QC on W&M PCBs

Justin Evans, Mark Langstaff & Hamza Iqbal

5th August 2024

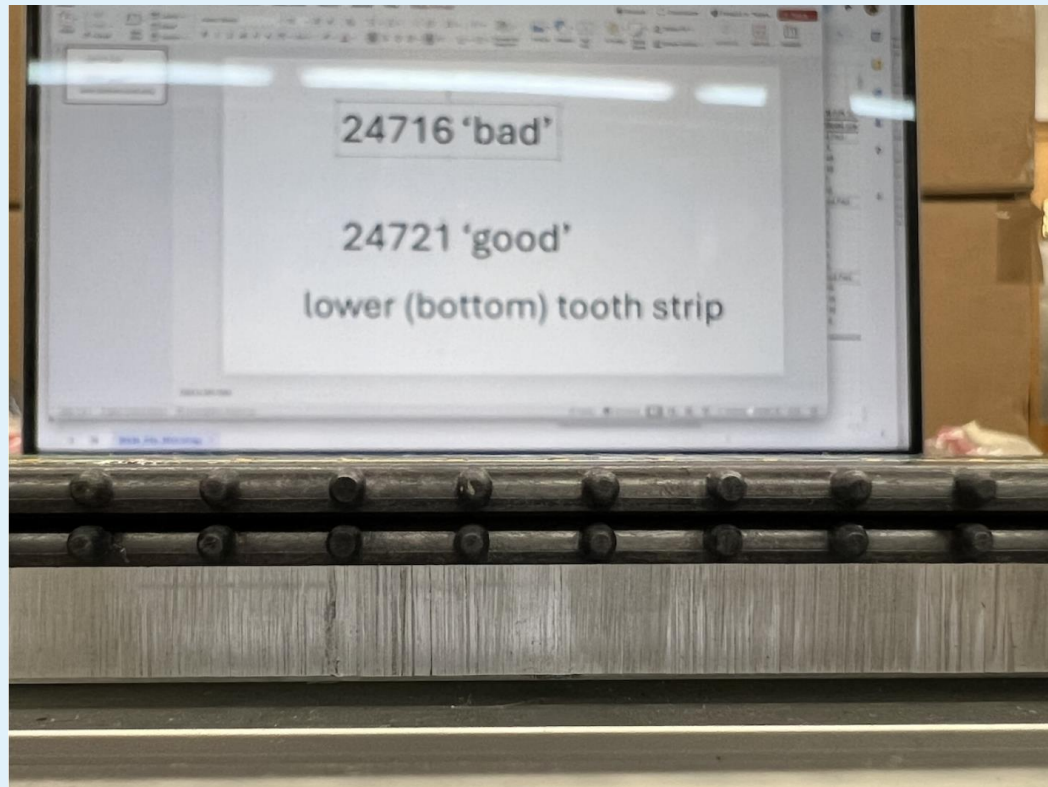
This is an example of a 'bad' board

- UK ID 24716, showing the 'bottom' tooth strip
- Shifted slightly to the right

In all cases, Justin didn't tell Hamza what to expect, and in all cases Hamza was able to identify a shift consistent with that seen by the Keyence

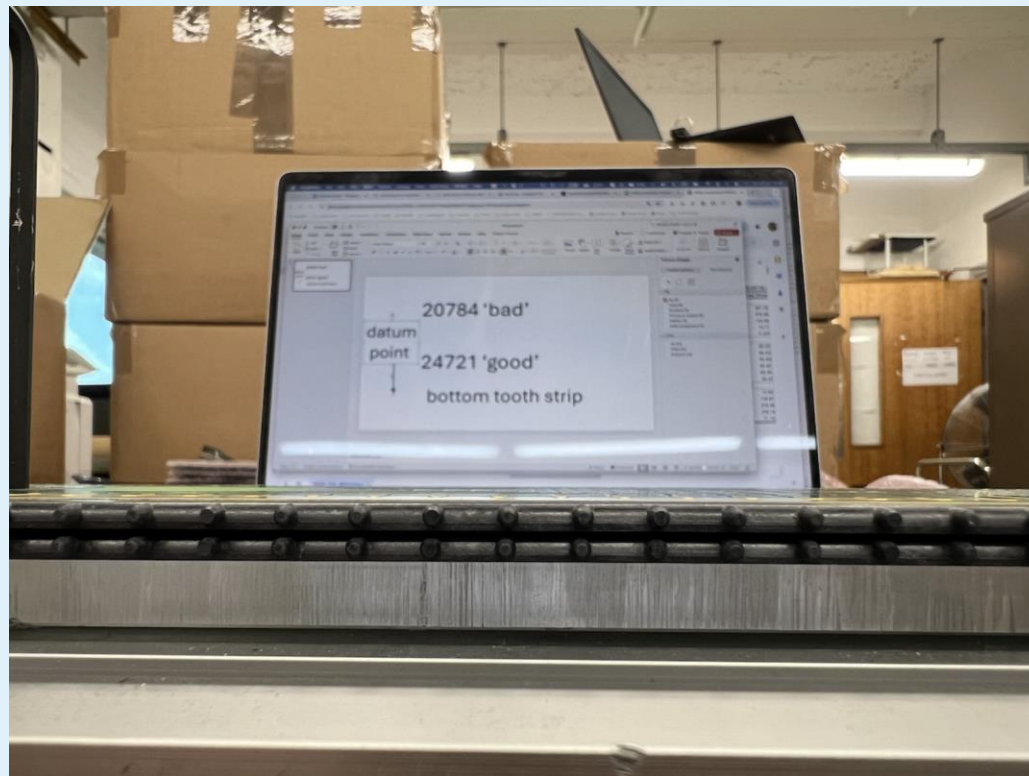
Another example of a 'bad' board

- UK ID 20786, showing the 'bottom' tooth strip
- Shifted slightly to the right

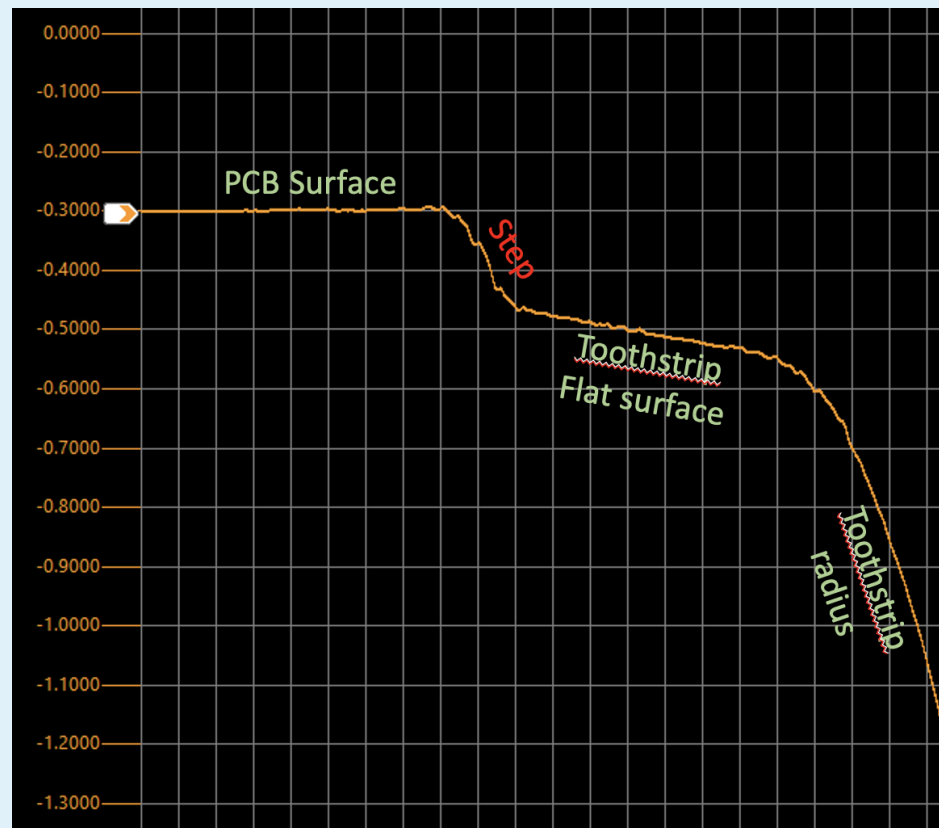
An example of a good board

- UK ID 24723, showing the 'bottom' tooth strip
- No visible offset

Examples of scans (board 18282)

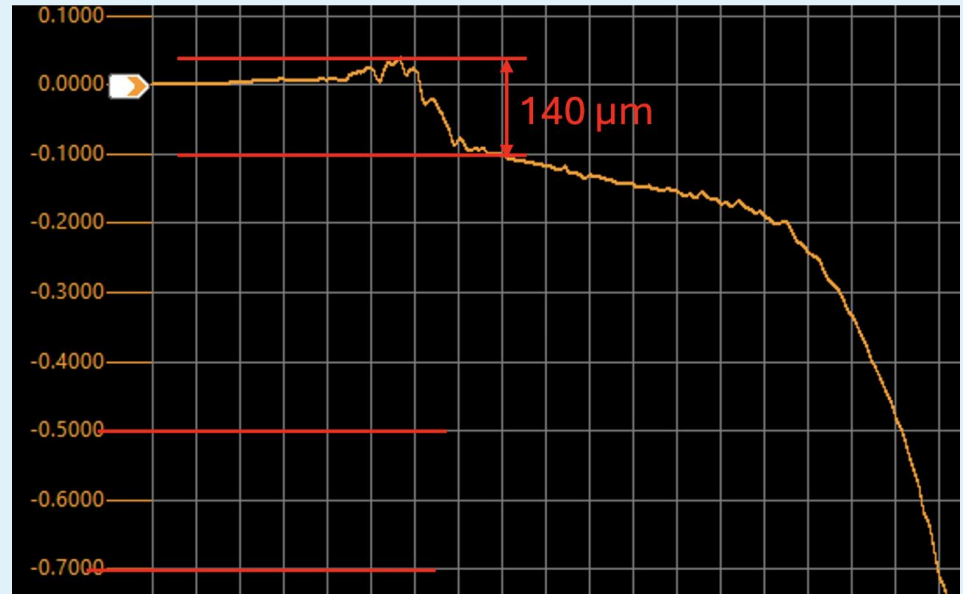
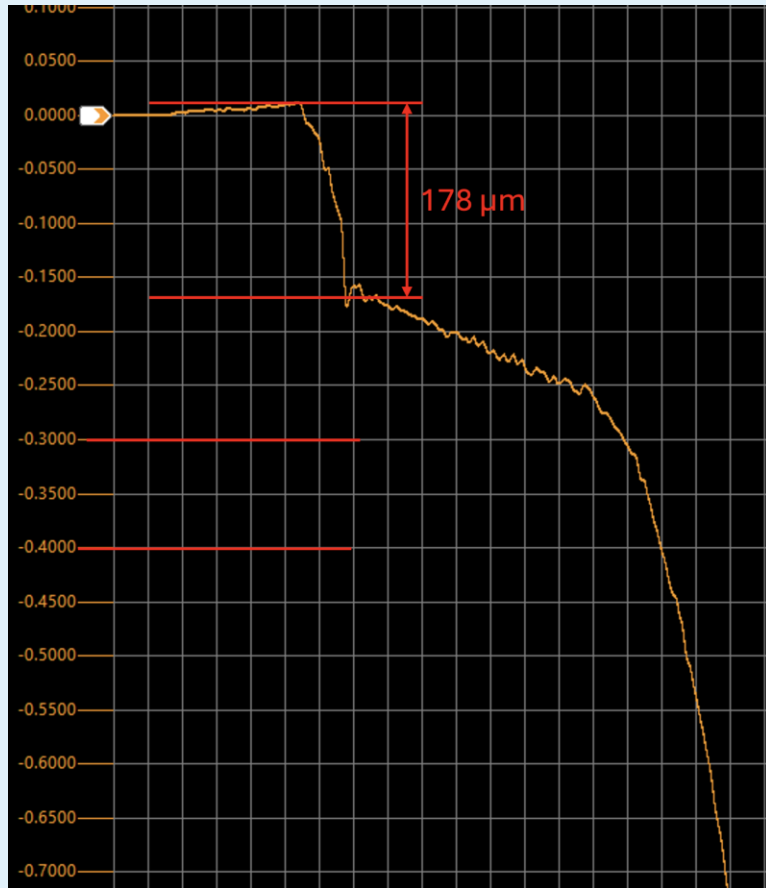
Typically the dial indicator overestimates the size of the step with respect to the laser scan by some tens of μs

- The laser scan would have passed board 18282, failed board 20715, and would 'just' have failed 23392
